WARNERVALE TOWN CENTRE CIVIC PRECINCT - SUMMARY OF DRAWING CHANGES

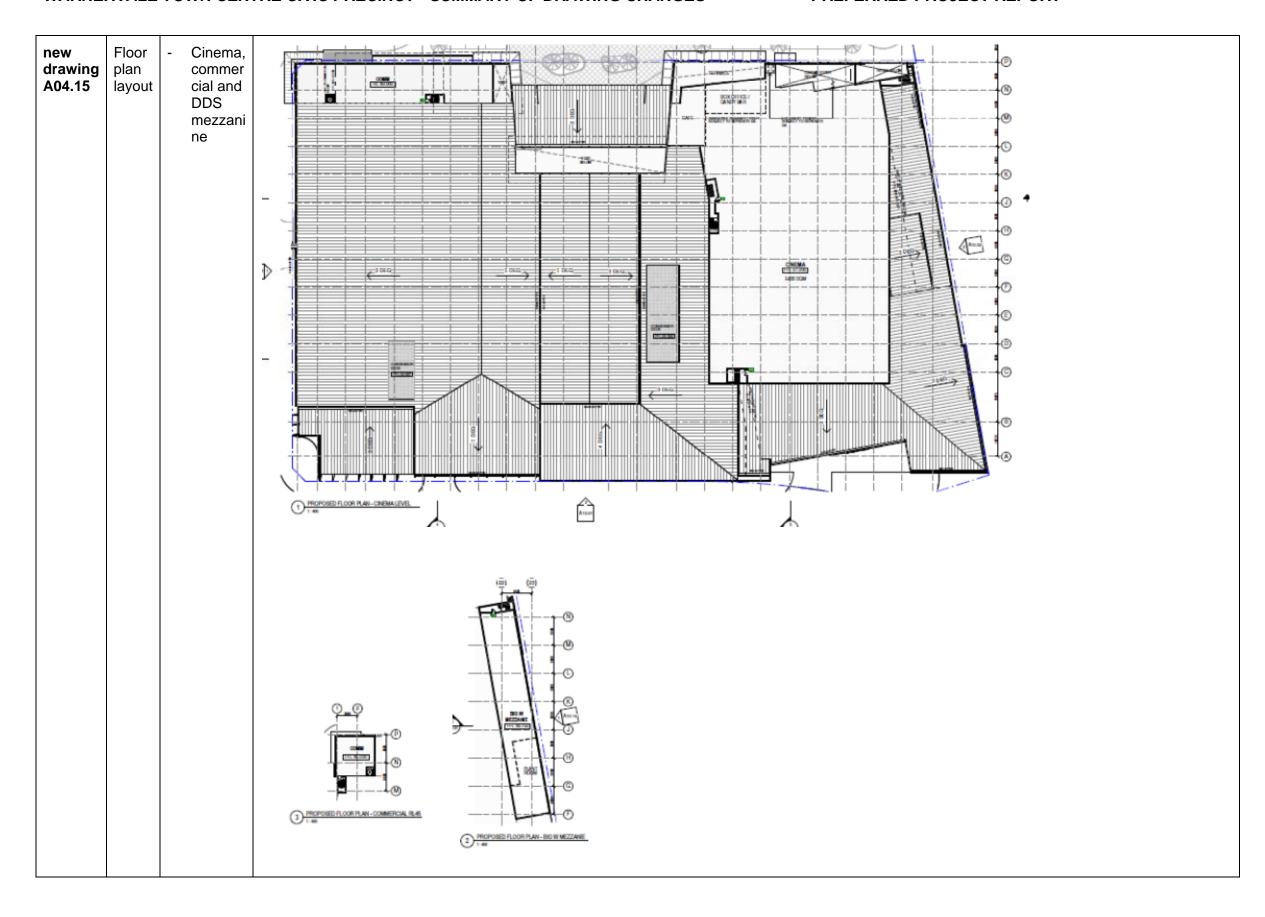
DRAWING REFERENCE	AREA AFFECTED	SUMMARY	OLD DRAWING INFORMATION	NEW DRAWING INFORMATION
	Floor plan layout	 Amenities changes. Rear of retail access changes. 	Amenities	FOOD COURT
	Floor plan layout	- Relocated lift.		
	Floor plan layout	- New access to retail premises.	RETAIL	RETAIL
	Floor plan layout	- Building edge changes.	RL 46,000 MINI MAJOR 160sq.m 150sq.m	COUNT FOOD COURT AMENTES COURT
	Floor plan layout	 Plant room changes. Woolworths changes (admin). Recycling/storage area changes. New commercial access. 	De la Company	RETAIL STATE OF THE STATE OF TH
